Appln No. 09/729,443

Amdt date March 18, 2005

Reply to Office action of December 22, 2004

**Amendments to the Drawings:**

Figure #1  
Prior Art

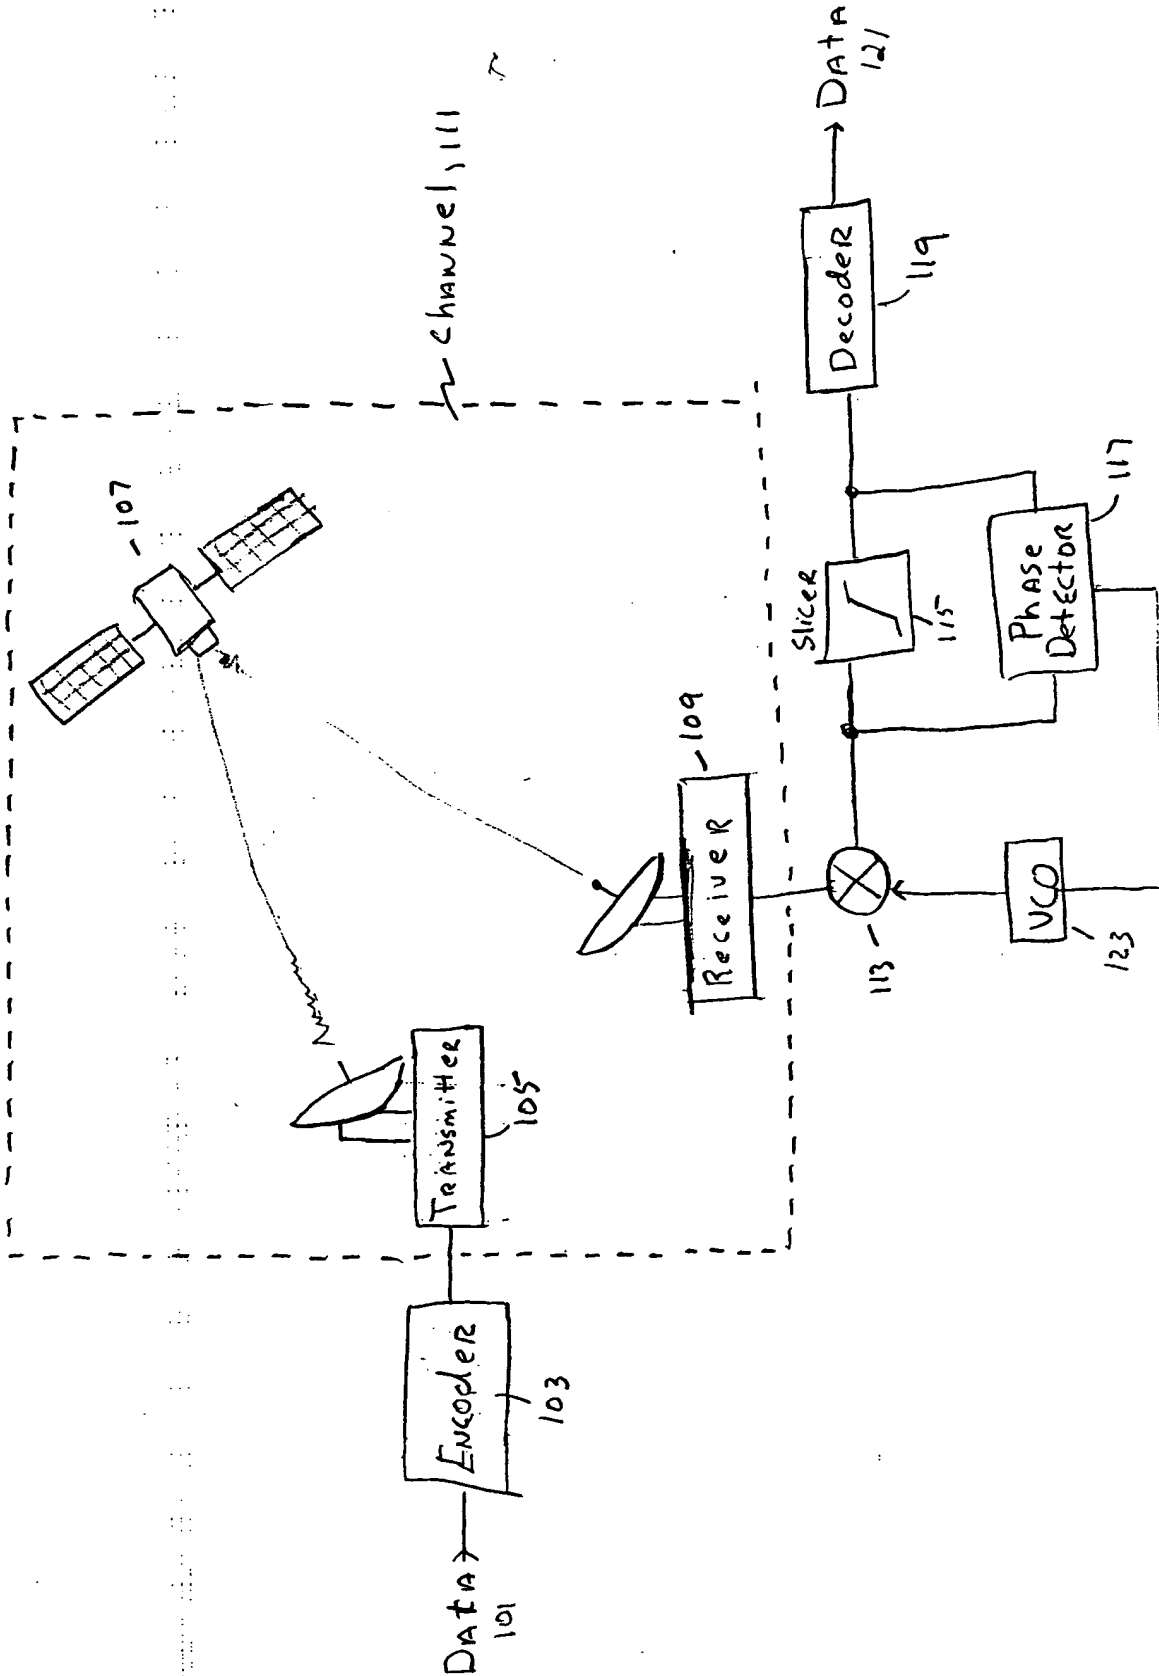
Figures 1 and 2 are objected to requiring these drawings to include a legend identifying them as "Prior Art." Figures 1 and 2 are amended and appropriately corrected drawings are enclosed. Accordingly, it is respectfully requested that the above objection be withdrawn.

The attached sheets of drawings include changes to Figs. 1 and 2. These sheets, which include Figs. 1 and 2, replace the original sheets including these figures.
